**STATE OF TENNESSEE
DEPARTMENT OF TRANSPORTATION**

INSTRUCTIONAL BULLETIN NO. 16-09

Regarding Revised, New and Voided Standard Drawings

Effective December 2, 2016 letting (September 27, 2016 Turn-in), the following Standard Drawings have either been revised, are new, or have been voided. Also, Section V of the Roadway Design Guidelines will be revised to incorporate these changes.

ROCK
 CHECK DAM

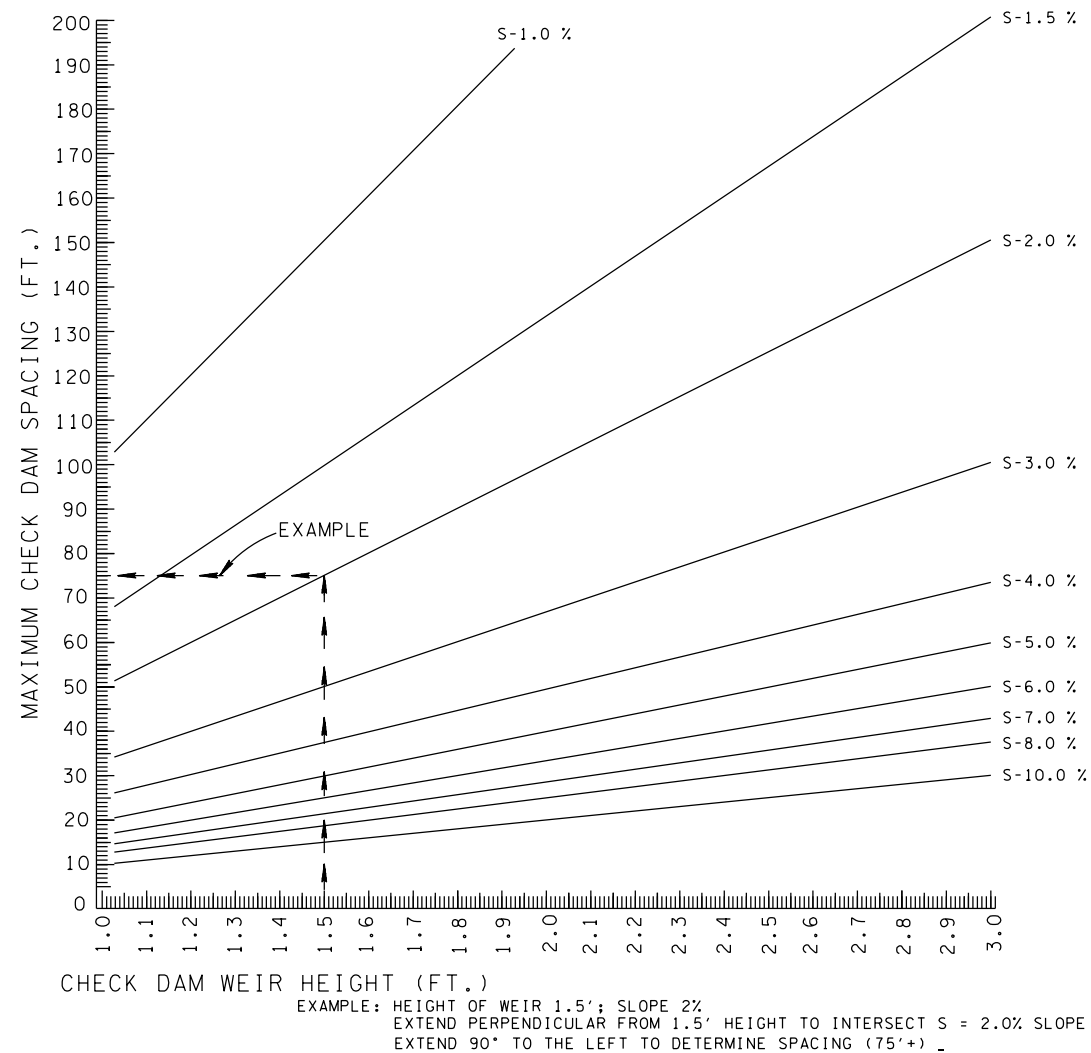
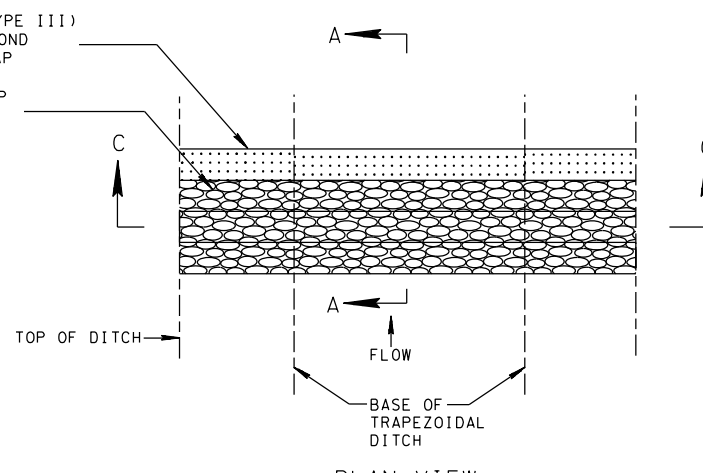
□ REV. 8-1-12: MINOR EDITS TO GENERAL NOTES.
 □ REV. 5-6-16: REVISED GENERAL NOTE ⑩

DETAILS OF
STANDARD CONCRETE
DRIVEWAYS

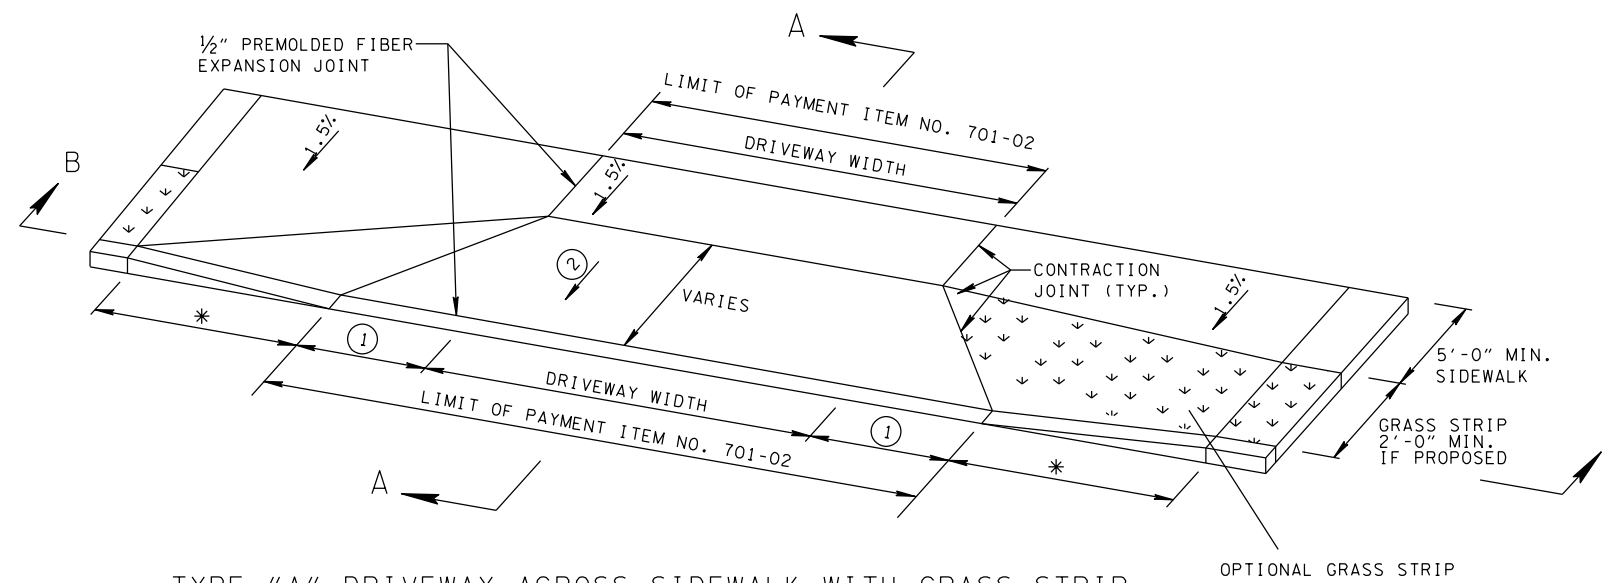
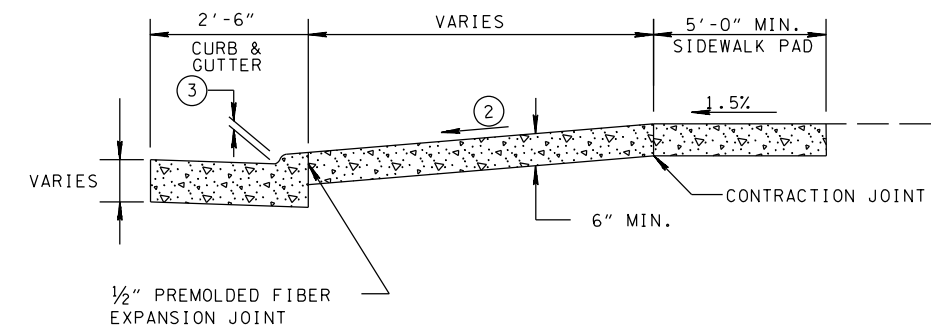
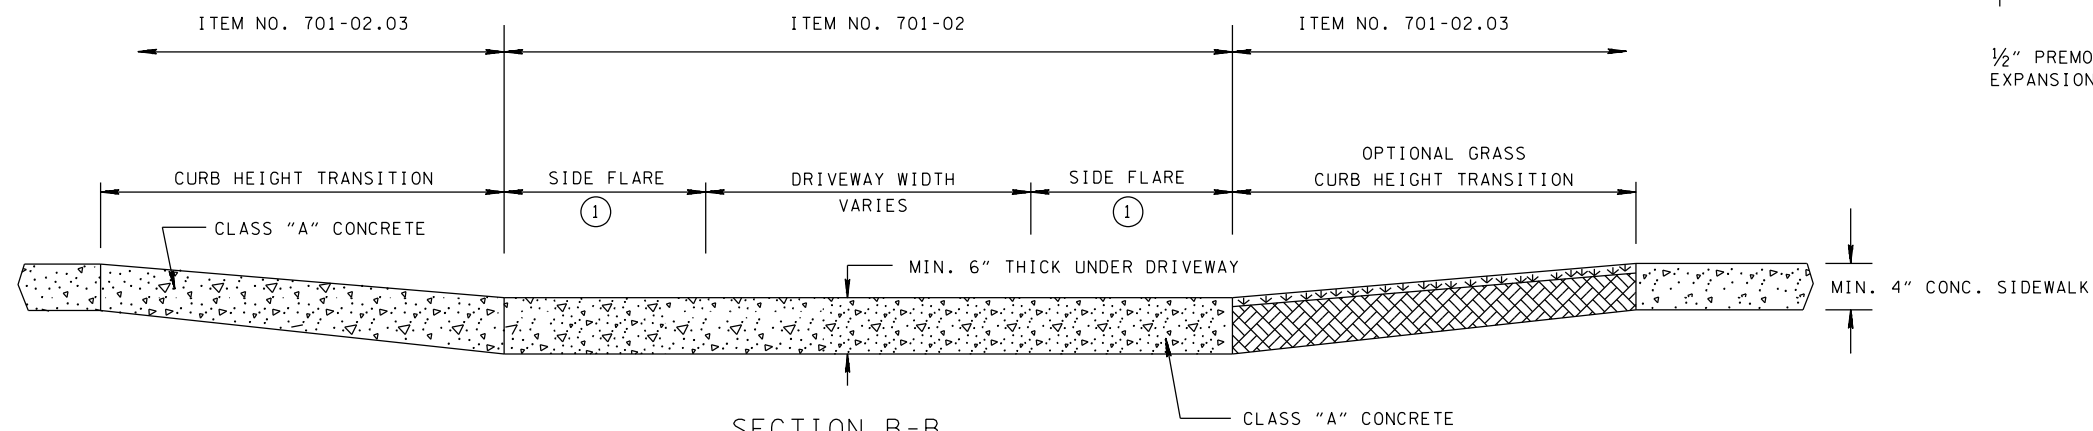
REV. 4-8-16: ADDED ITEM NUMBERS, UPDATED SLOPES AND DIMENSIONS. UPDATED NOTES.

DETAILS OF
LOWERED STANDARD
CONCRETE
DRIVEWAYS

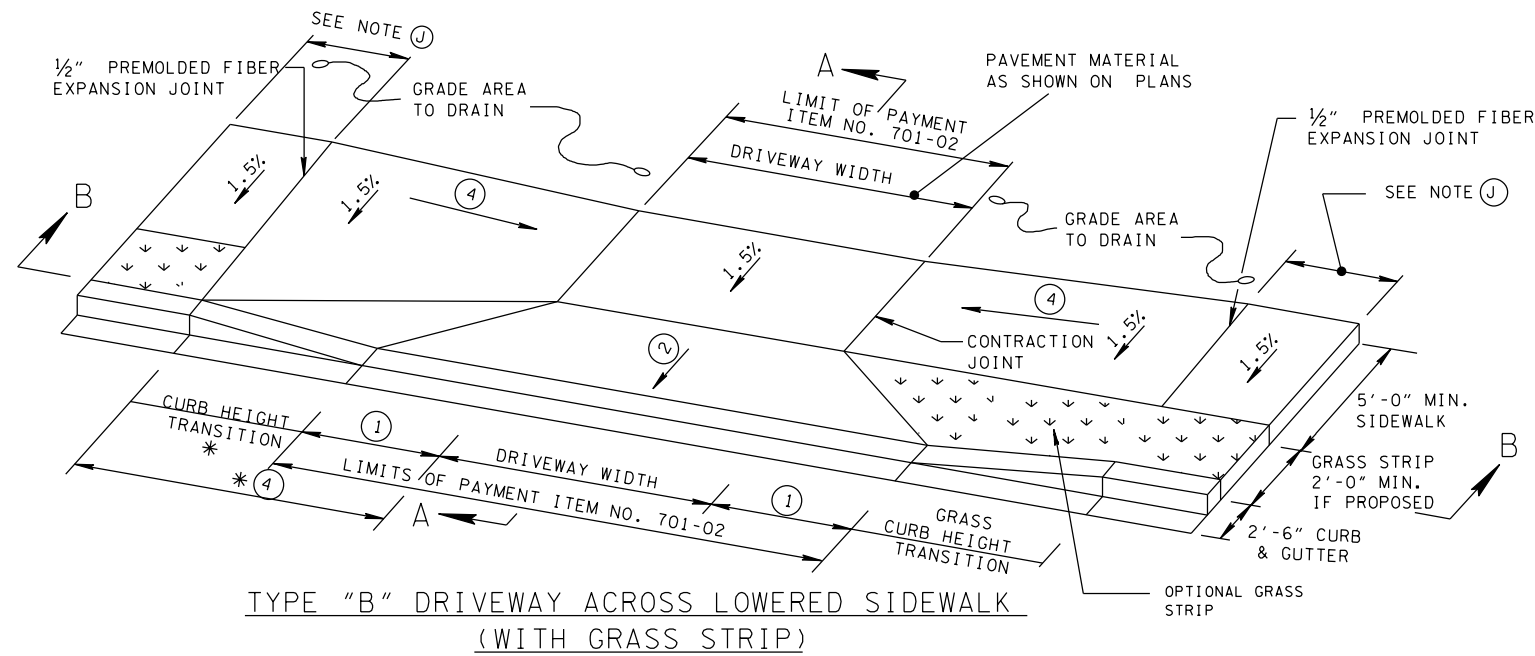
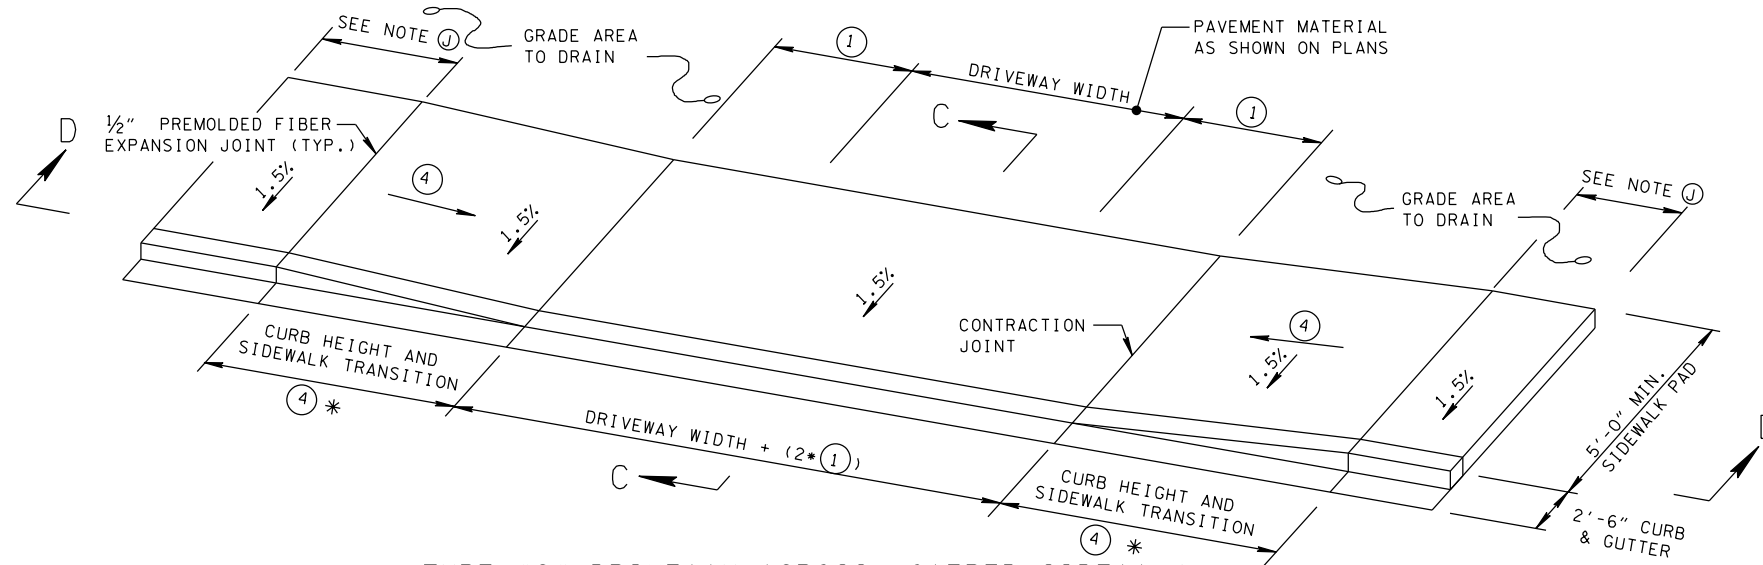
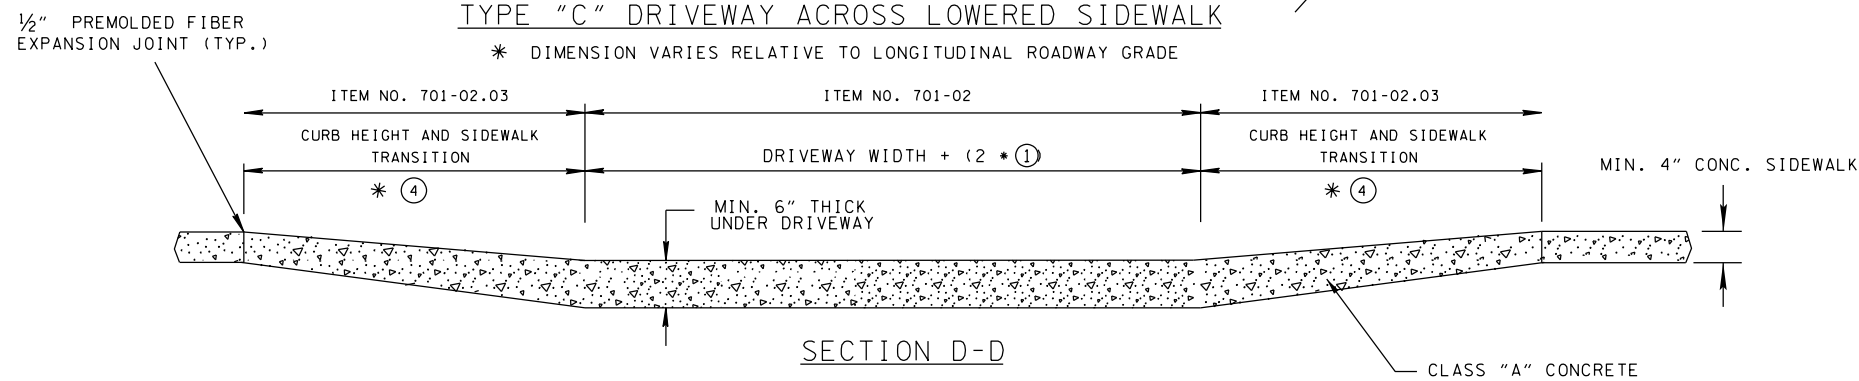
REV. 4-8-16: ADDED ITEM NUMBERS, UPDATED SLOPES AND DIMENSIONS. UPDATED NOTES.

STATE OF TENNESSEE
 DEPARTMENT OF TRANSPORTATION
 TYPE 38
 GUARDRAIL END
 TERMINAL
 7-11-13 S-GRT-2

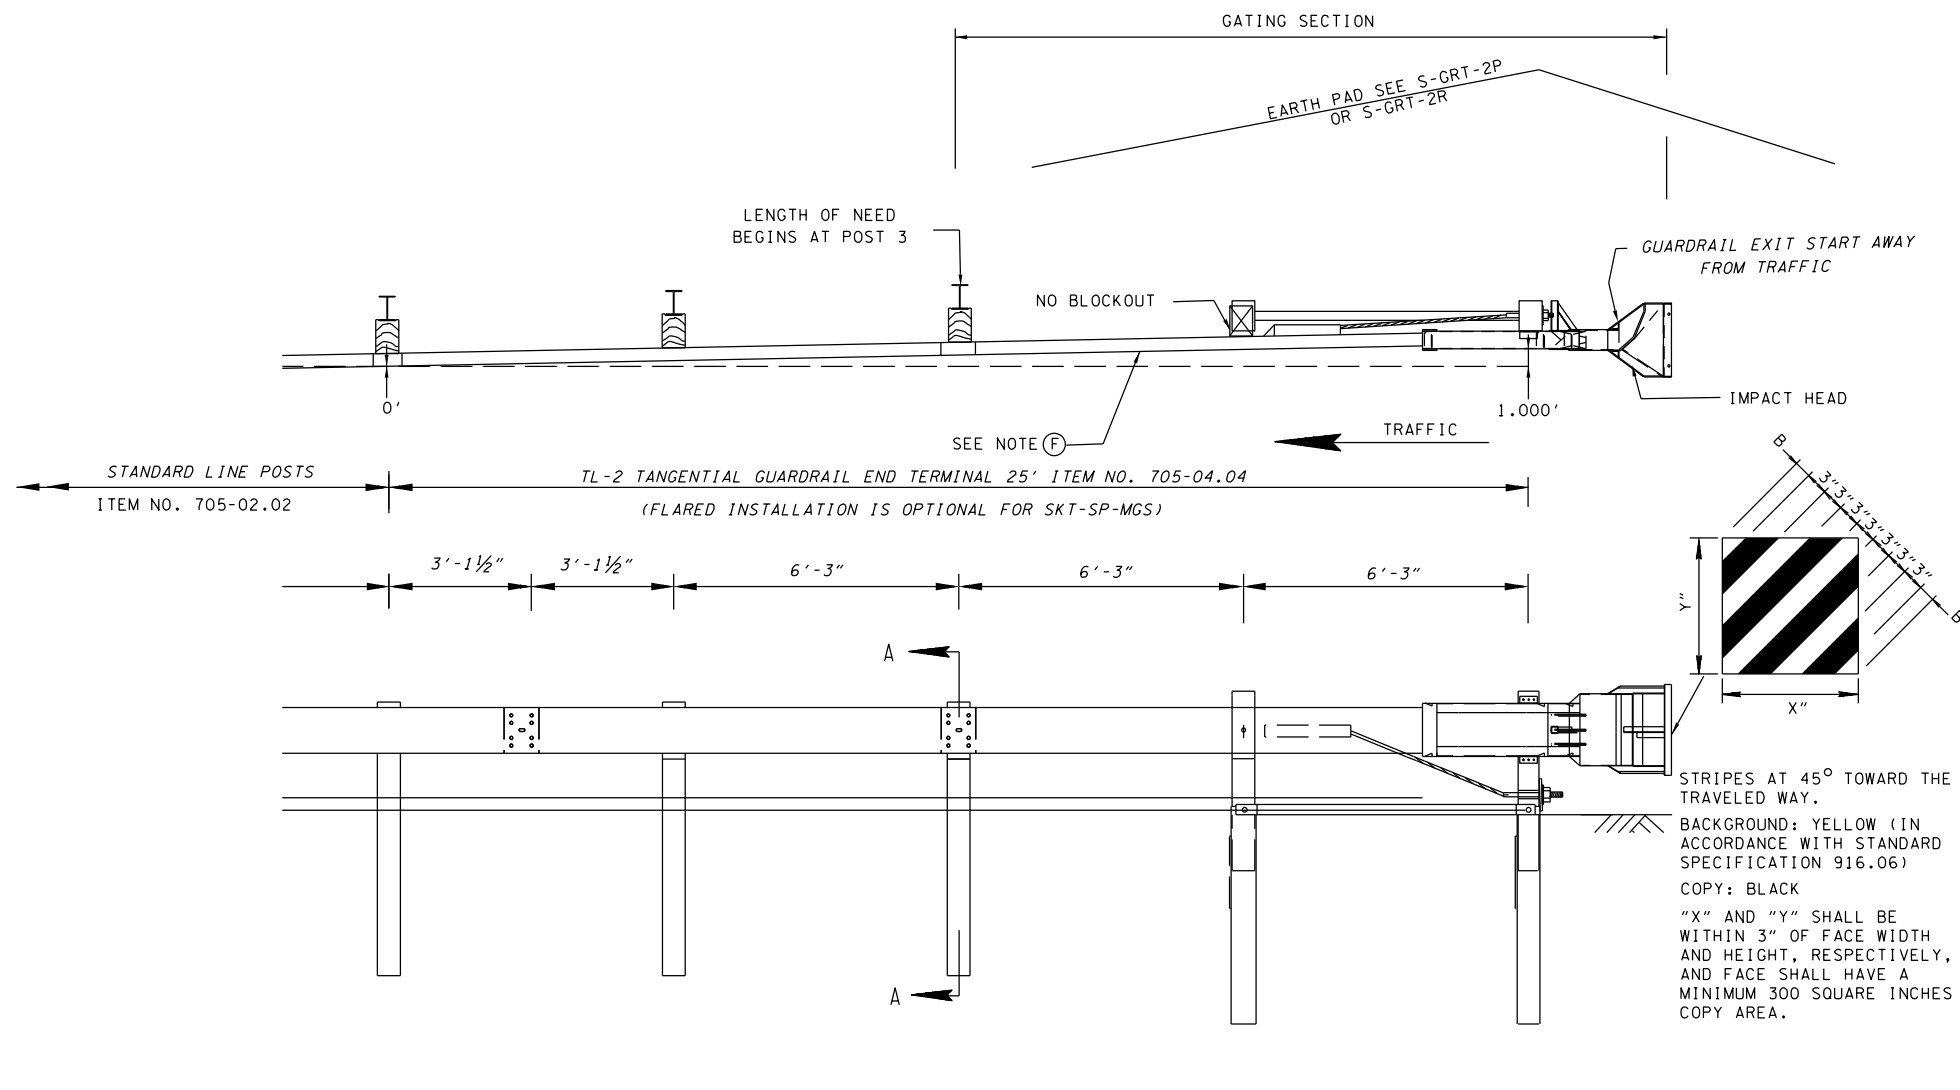
REV. 4-4-16: THE PREVIOUSLY SHOWN SKT75 (SLOTTED FLARED GUARDRAIL TERMINAL) IS NO LONGER AVAILABLE FOR 31" INSTALLATION. REVISED TO SHOW TL-2 T-350 TERMINAL.
